ADDENDUM
NO. 1

July 27, 2026

MERRILLVILLE HS CULINARY AND MEETING AREA RENOVATIONS AND MERRILLVILLE CSC CENTRAL OFFICE ADDITION AND RENOVATION PROJECT

This Addendum consists of pages ADD 1-1 through ADD 1-5 and attached and attached Addendum No. 1 from Gibraltar Design dated July 24, 2026, and consisting of 8 pages, revised Specification Section 08 71 00 - Door Hardware and 47 Drawings.

DRAWING
UNIT "T" MECHANICAL PIPING FIRST FLOOR PLAN

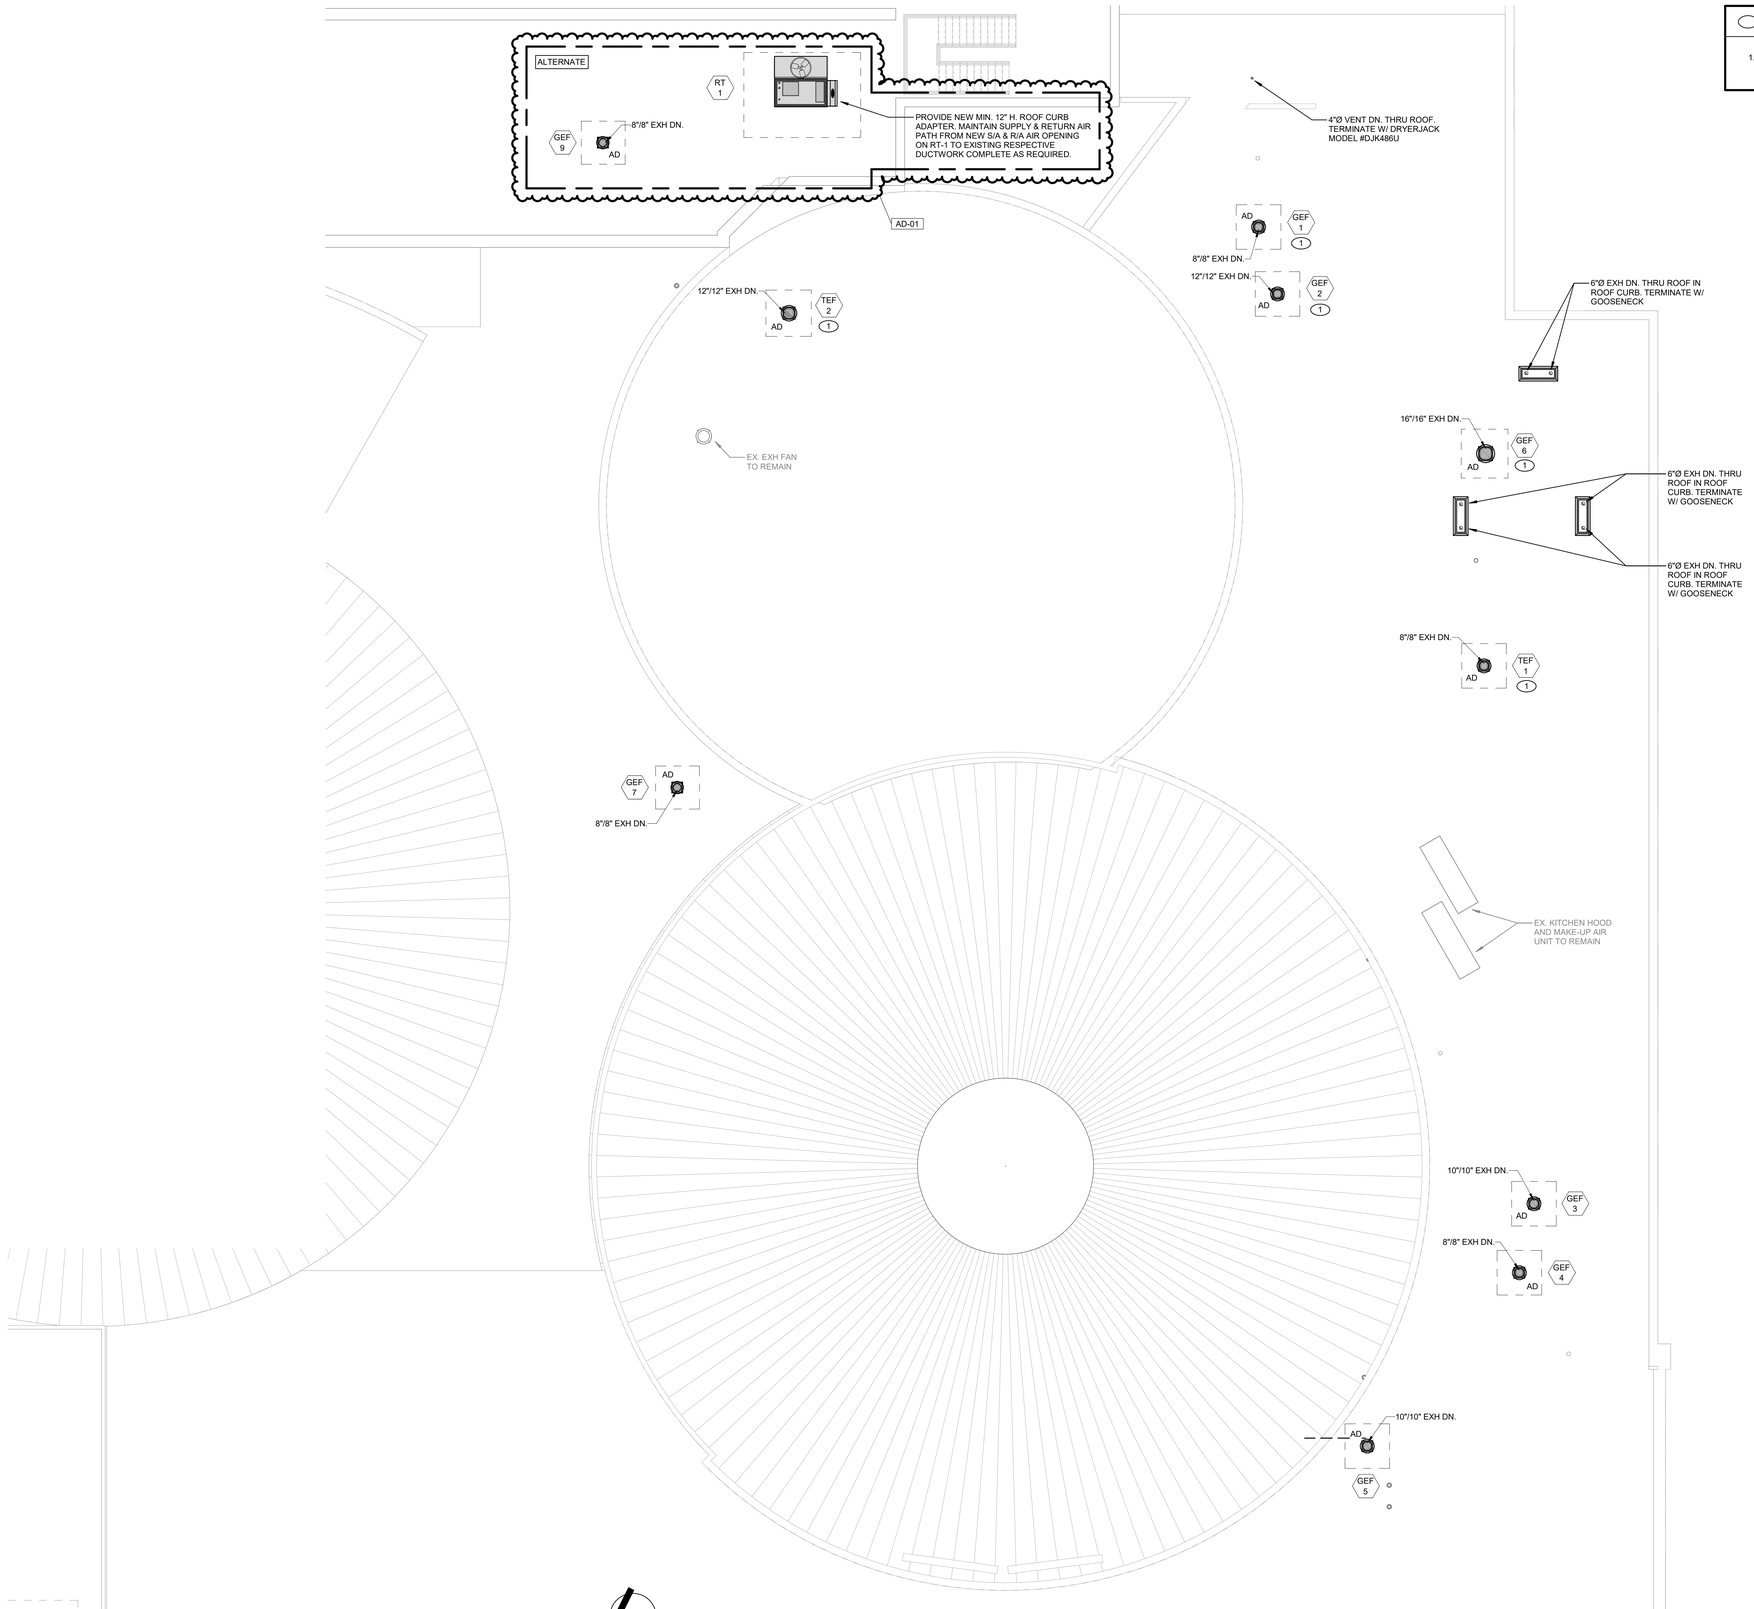
26. Sheet MP121

A. Refer to revised, full-size drawing, included in this Addendum, for revisions.
   1. Added note for existing gas piping and kitchen equipment.
   2. Added thermostats to electrical and technology room.

DRAWING
UNIT "T" PLUMBING FIRST FLOOR DEMOLITION PLAN

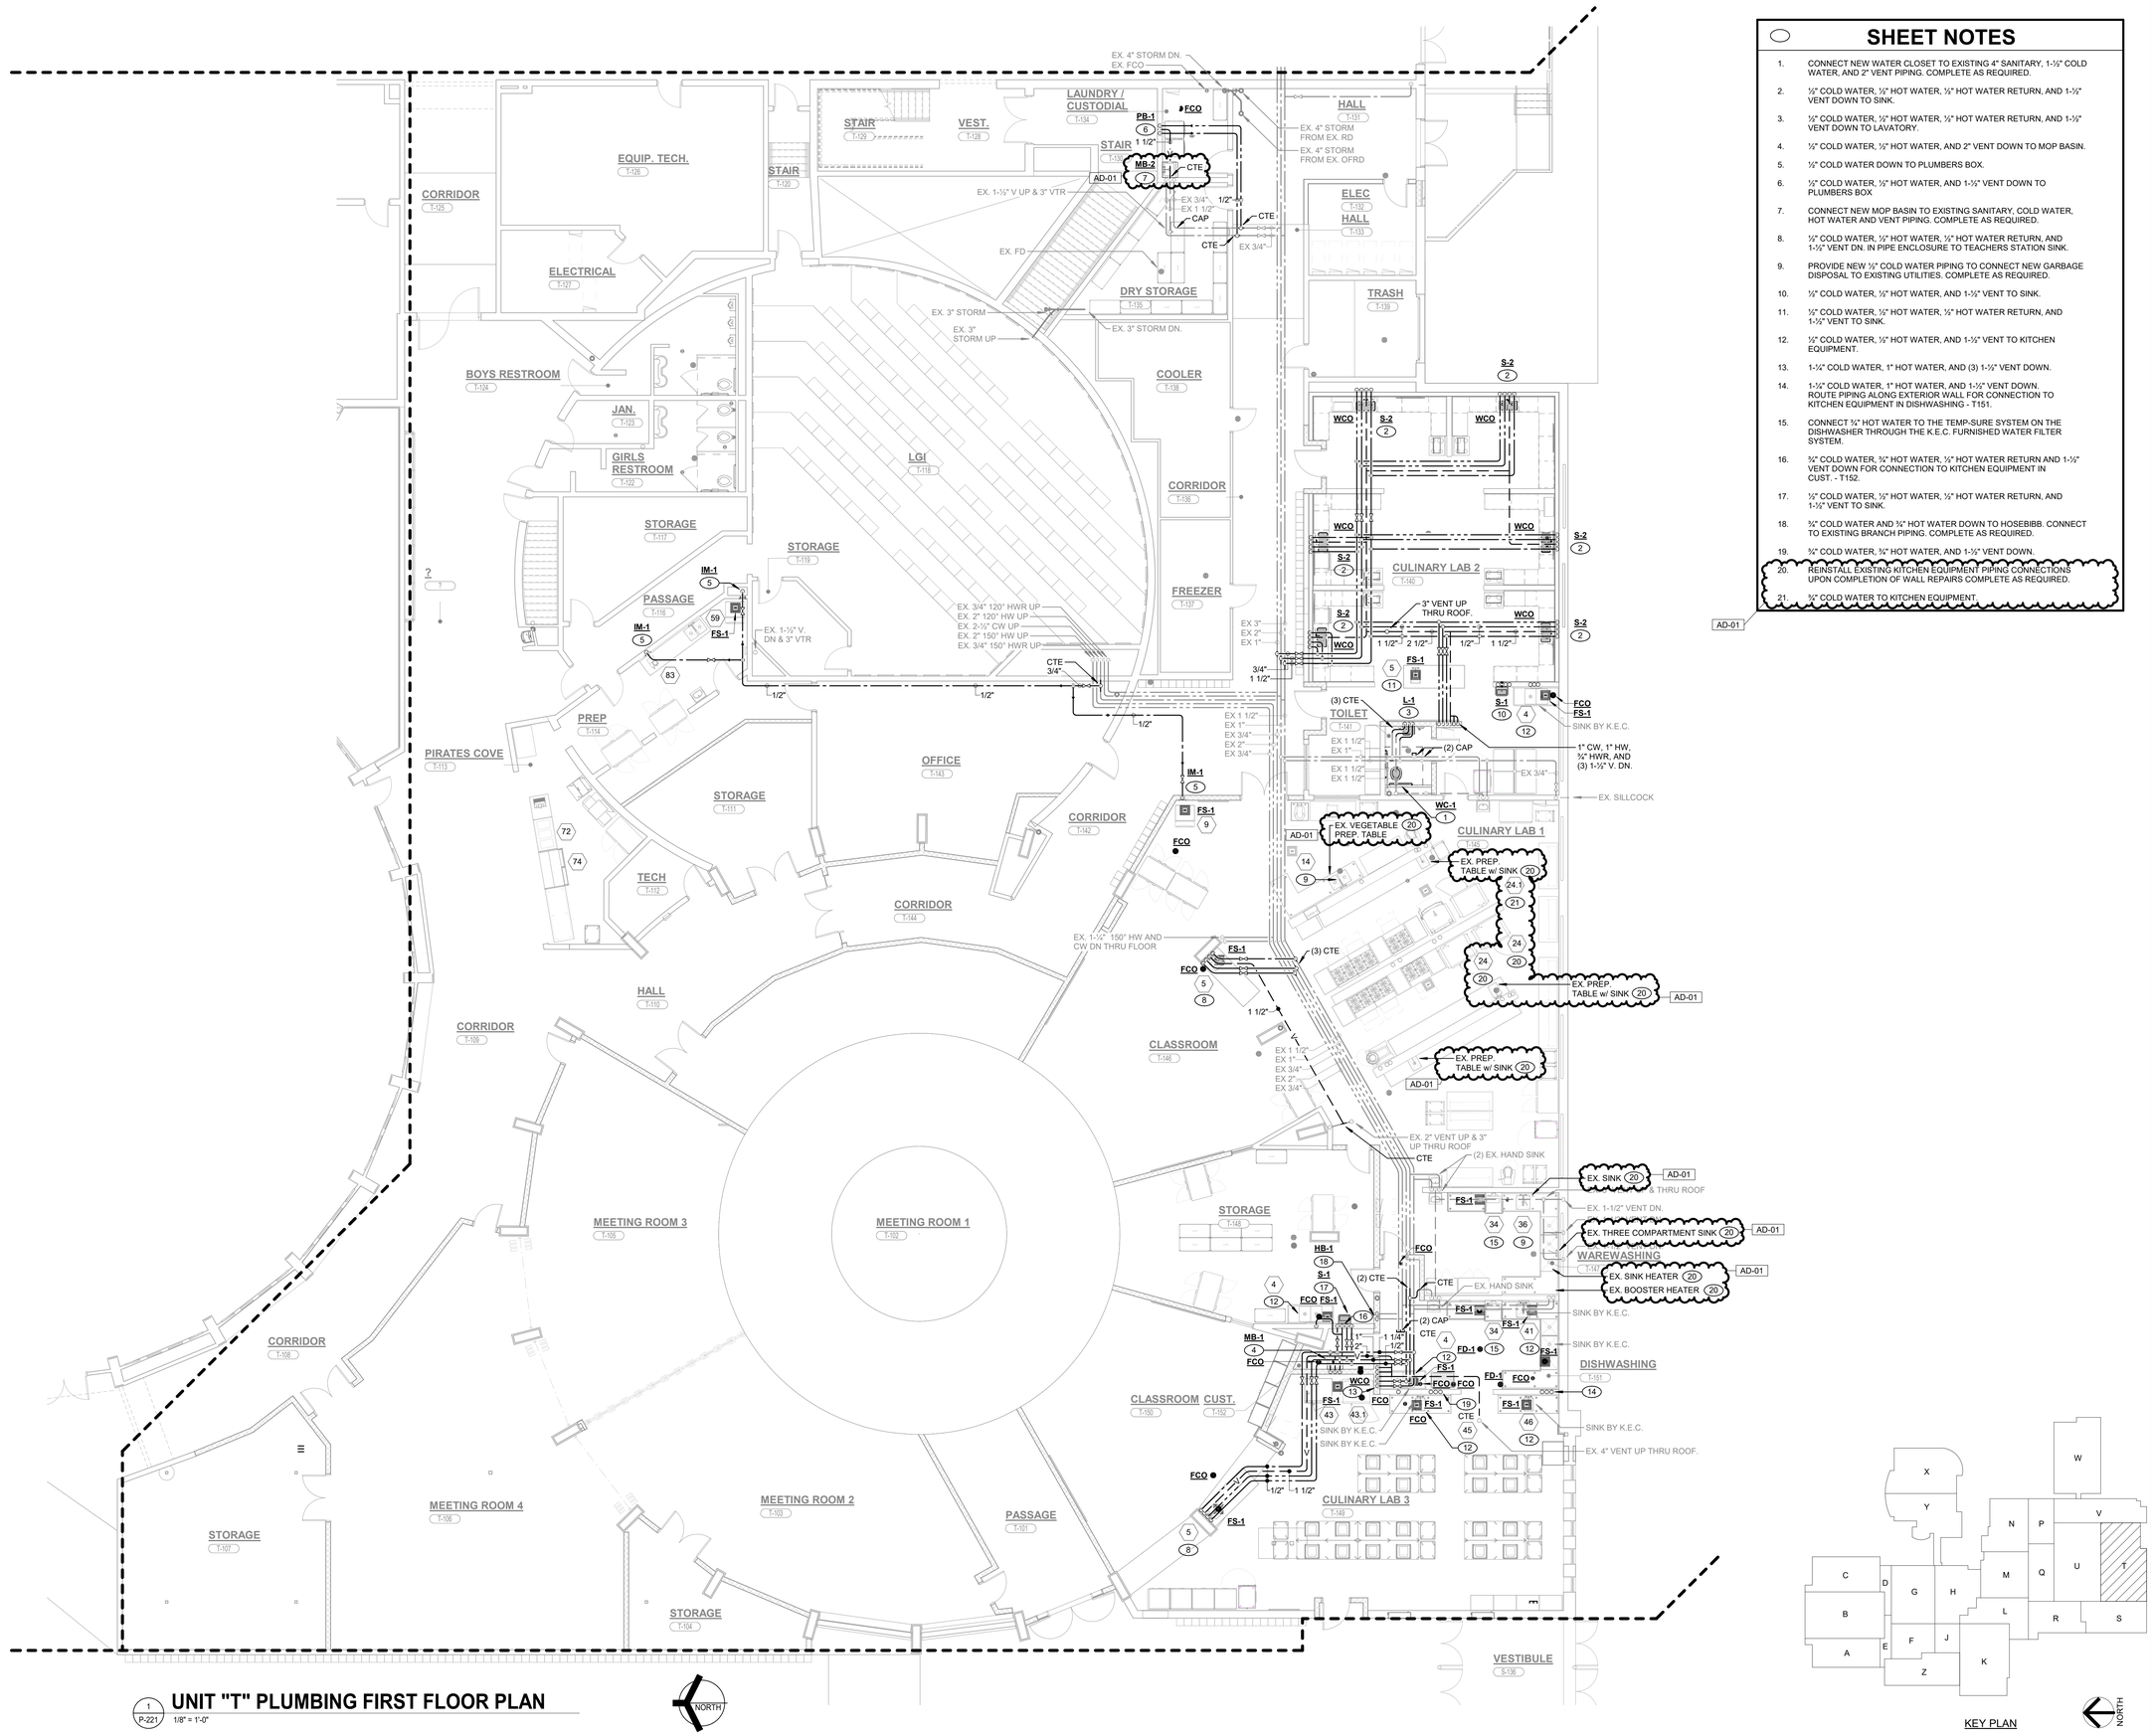
19. Sheet PD121

A. Refer to revised, full-size drawing, included in this Addendum, for revisions.
   1. Added Sheet Note #12.
   2. Revised Sheet Note #16.
   3. Added notes pertaining to the removal and protection of piping resultant of the repair of existing wall(s).

DRAWING
UNIT "T" ELECTRICAL LIGHTING FIRST FLOOR PLAN

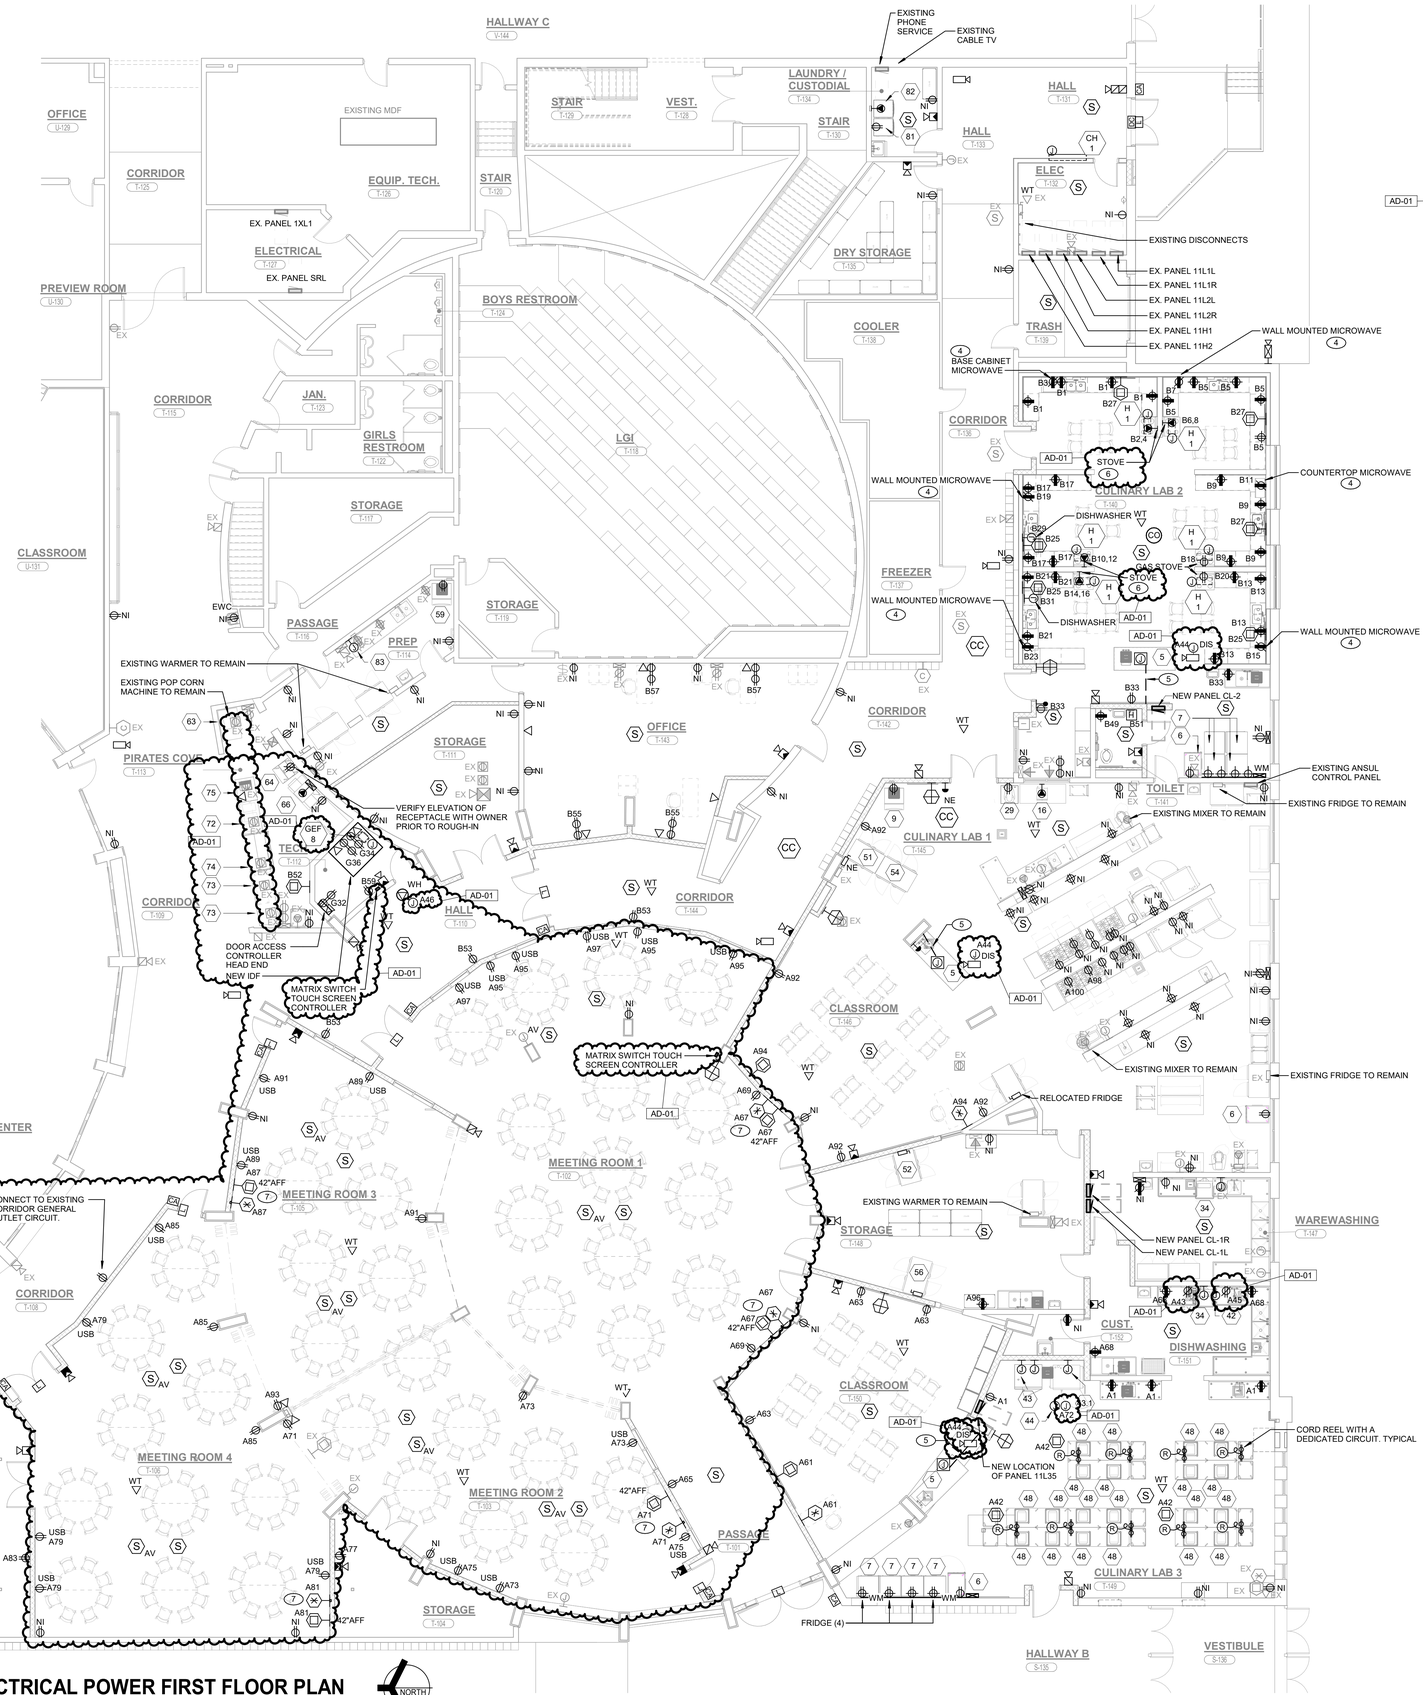
32. Sheet EL121

A. Refer to revised, full-size drawing, included in this Addendum, for revisions.
   1. Coordinated lighting layout in Culinary Lab 2 with oven hoods.
   2. Added and removed multiple exit signs from lighting plan.
   3. Added touch screen controllers.

ELECTRICAL ONE-LINE SCHEMATIC DIAGRAM

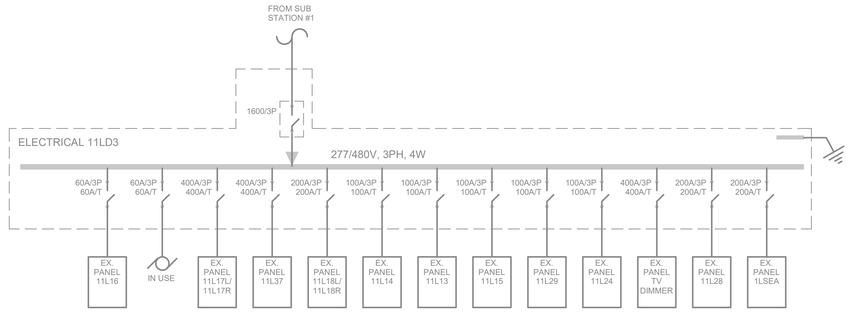
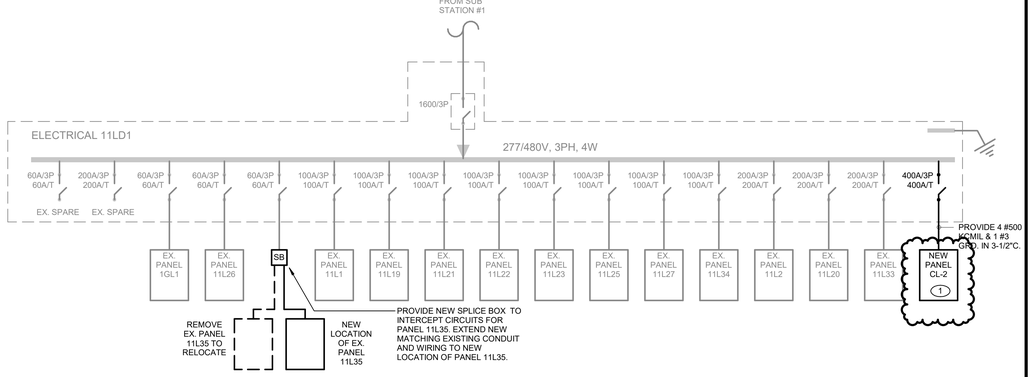
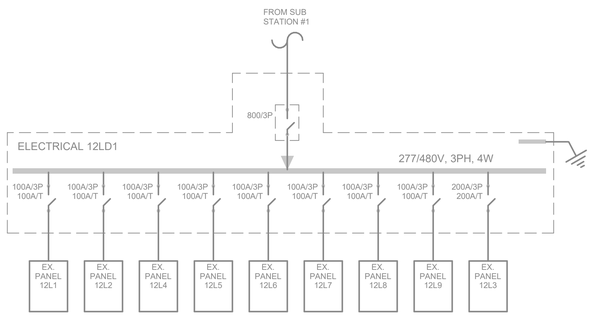
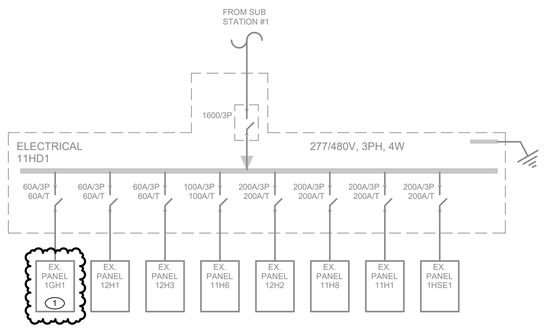
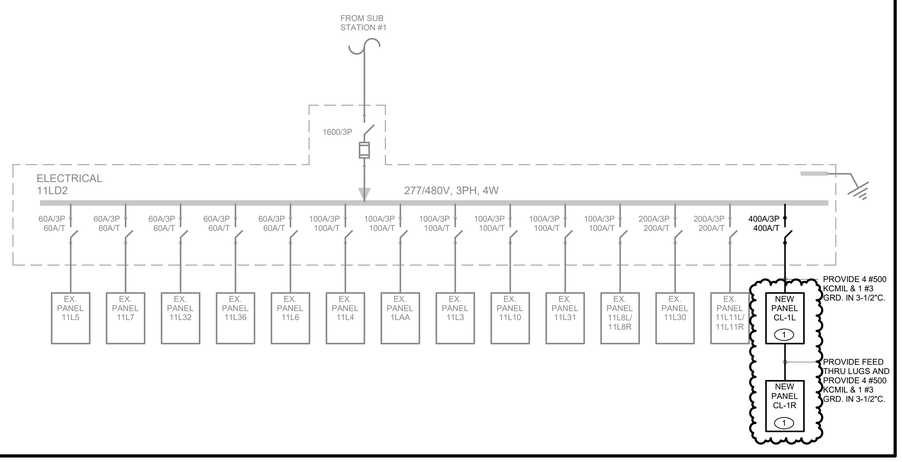
37. Sheet-E602

A. Refer to revised, full-size drawing, included in this Addendum, for revisions.
   1. Added detail note one to one-line.
